2011-102 _____ BWR Vessel & Internals Project (BWRVIP)

Subject: Project No. 704 – BWRVIP Response to NRC Request for Additional Information on BWRVIP-138, Revision 1

Non-Proprietary BWRVIP Response to NRC Request for Additional Information on “BWRVIP-138, Revision 1: BWR Vessel and Internals Project, Updated Jet Pump Beam Inspection and Flaw Evaluation Guidelines”

Figure 1. Cumulative Nickel Release from Autoclaved and Pre-oxidized Alloy X-750 [2]

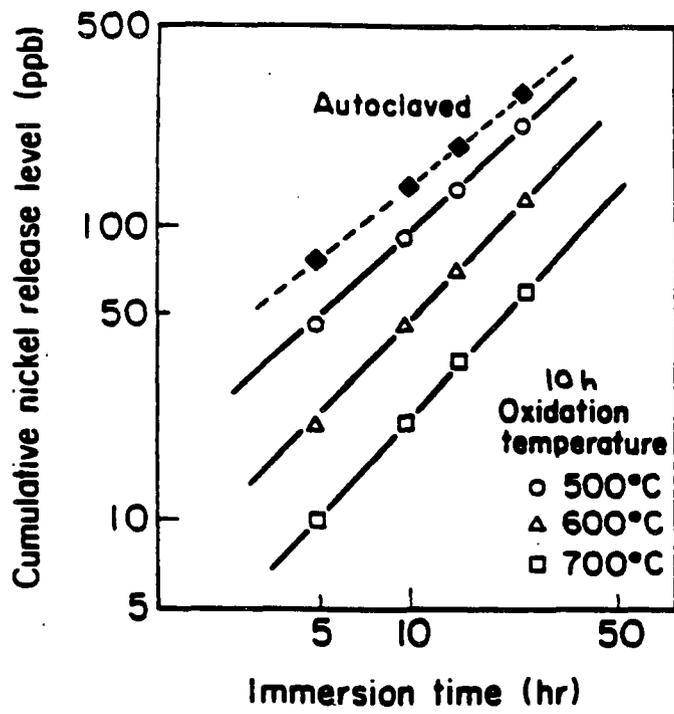
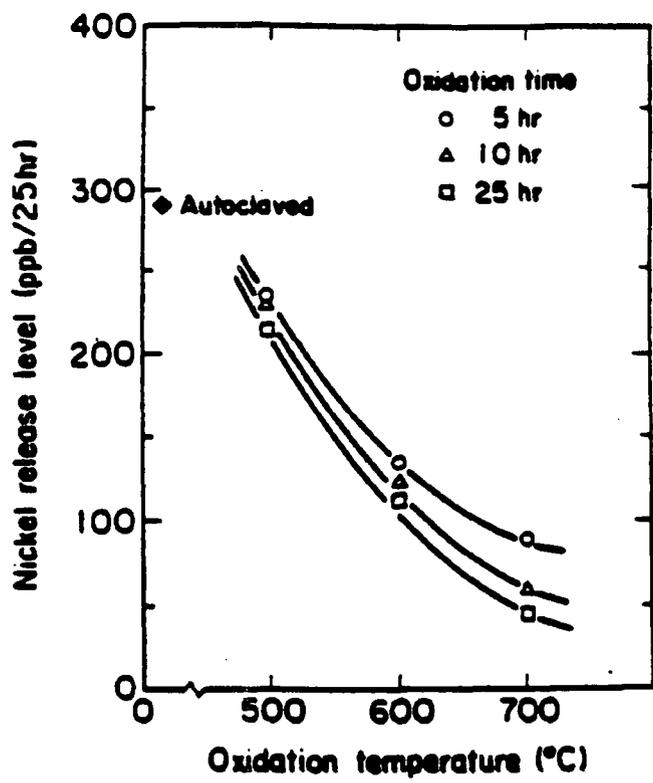
Has the BWRVIP considered the effect of surface condition on initiation of stress corrosion cracking? A paper from Foucault and Benhamou, “Influence of the Surface Condition on the Susceptibility of Alloy X-750 to Crack Initiation in PWR Primary Water” 1993, TMS 6th International Symposium of Environmental Degradation of Materials in Nuclear Power Systems-Water-Reactors is potentially relevant. This is not the boiling water reactor (BWR) environment, but it is possible that the surface condition is important in both BWR and pressurized water reactor (PWR) environment in terms of initiation.

K. Tada, et al. examined air oxidation as a candidate surface treatment for mitigation of Alloy X-750 general corrosion in BWR type environments [2]. Oxide layers on Alloy X-750 were characterized to determine their relationship with subsequent corrosion using solution heat treated (SHT) Alloy X-750 in a vacuum followed by either air oxidation at 500-700°C (932-1292°F) for a maximum of 25 hours or autoclaved at 390°C (734°F) for 13 hours after aging as a control.

The results of the study revealed that the oxides varied in thickness from 30 nm (as-autoclaved) to 270 nm (as-oxidized plus immersion) and there were no obvious differences in oxides on pre-oxidized Alloy X-750 before and after short term 280°C (536°F) immersion. However, the oxide layer consisted of a thin film plus oxide particles on the film. The film was the spinel $FeNiFeO_4$ plus Cr_2O_3 and NiO while the oxide particles were also $FeNiFeO_4$. Specimens pre-oxidized for 10 hours at 500-700°C (932-1292°F) had 30-90% lower nickel release levels than the non-pre-oxidized material, Figure 1, and the nickel release level decreased with increasing pre-oxidation temperature and pre-oxidation time, Figure 2.

Figure 7. Stress versus Time to Failure for Alloy X-750 in 288°C (550°) Water in 8 ppm Dissolved Oxygen [8]

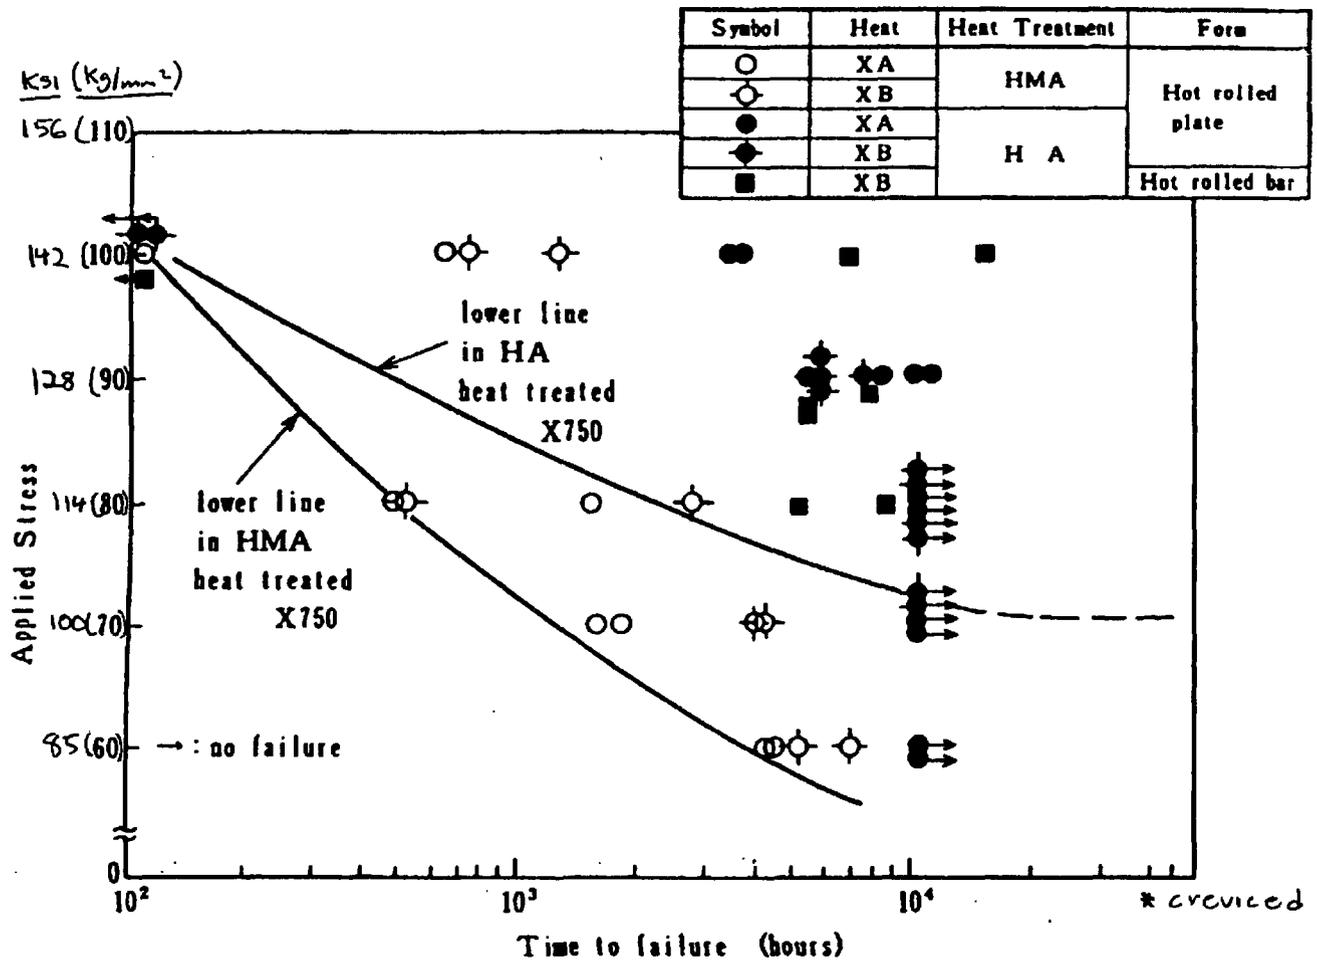
“Laboratory data for Alloy X-750 has shown a direct dependency of the time-to-initiation on the applied stress [2, 3].

Reference 2 includes design, procurement, fabrication and installation information for Alloy X-750, but no lab data while reference 3 is GE proprietary information. Provide the data discussed in the text or provide a reference document with this data.

All these studies have indicated that a high temperature anneal (1066°C [1950°F]/1 hour) followed by direct aging (704°C [1300°F]/20 hours) provides the optimum IGSCC resistance, but not immunity to IGSCC in BWR (and PWR) environments. In fact, some in-reactor, but not irradiated, testing of Alloy X-750 in this heat treatment has demonstrated excellent results. For example, no IGSCC has been observed on creviced and un-creviced Alloy X-750 constant load specimens after sixteen (16) years of in-reactor exposure at stress levels exceeding 120% of the 288°C (550°F) yield stress [15-16].

As shown in Table 1, the more susceptible AH (HMA in Figure 7) heat treated Alloy X-750 had γ' Ni₃(Al,Ti) and η phase Ni₃Ti in the grain boundaries. The needle-like η phase was accompanied by a precipitate free zone (PFZ) along the grain boundaries, no precipitated

chromium carbides and fine γ' particles precipitated in the PFZ. The more IGSCC resistant HTH (HA in Figure 7) heat treated Alloy X-750 had only chromium carbide $Cr_{23}C_6$. This suggests that the presence of η phase, PFZ and fine γ' particles in the PFZ have some detrimental effect on IGSCC resistance.

Figure 10. Crack Length vs. Time for Alloy X-750 AH Tested in 288°C Water [17, 18]

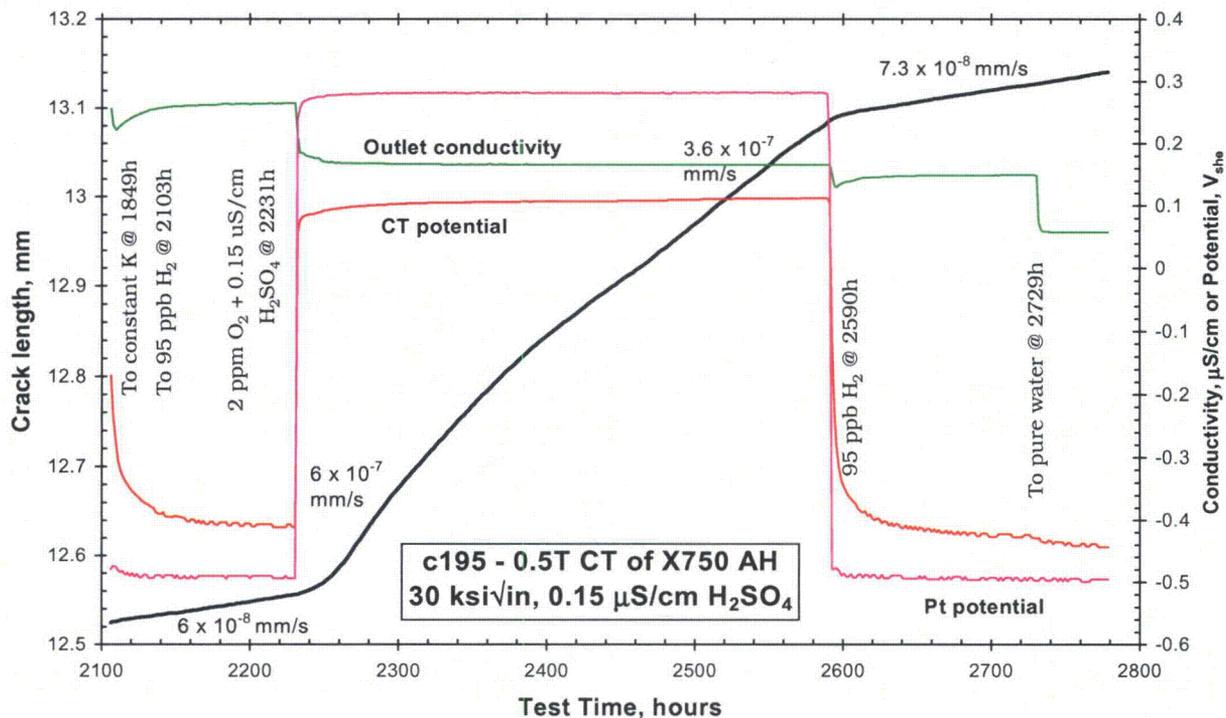
Elaborate on why data for Alloy 600 and austenitic stainless steels may or may not be applicable to Alloy X-750. What inputs were used to make these theoretical predictions and why is this trend important in this case given the fact that hold-down beams with EQA and high temperature heat treatments have nearly identical YS and are strengthened by precipitation instead of cold working as is the case for Alloy 600 and austenitic stainless steels? Does the theory support the

extrapolation of crack growth rate data to applied stress-intensity factor (K) values an order of magnitude lower than the applied K values for the measured crack growth rates?

As presented in Figure 10, which is reproduced from Figure 5.2² from BWRVIP-138, Revision 1 [17] and is also available in the open literature [18], HWC reduces the crack growth rates of Alloy X-750 in a similar manner it reduced the crack growth rates of cold worked Types 304, 304L and 316L stainless steel and Alloy 600. More specifically for Alloy X-750 AH, the factor of improvement (FOI) in crack growth rate reduction with the application of HWC is between approximately 5 and 10 as shown in Figure 10. It should be noted that the factor of improvement in crack growth rate proposed for Alloy X-750 in the HWC environment in BWRVIP-138, Revision 1 is only a factor of 2 which is very conservative as compared to the results presented in Figure 10.
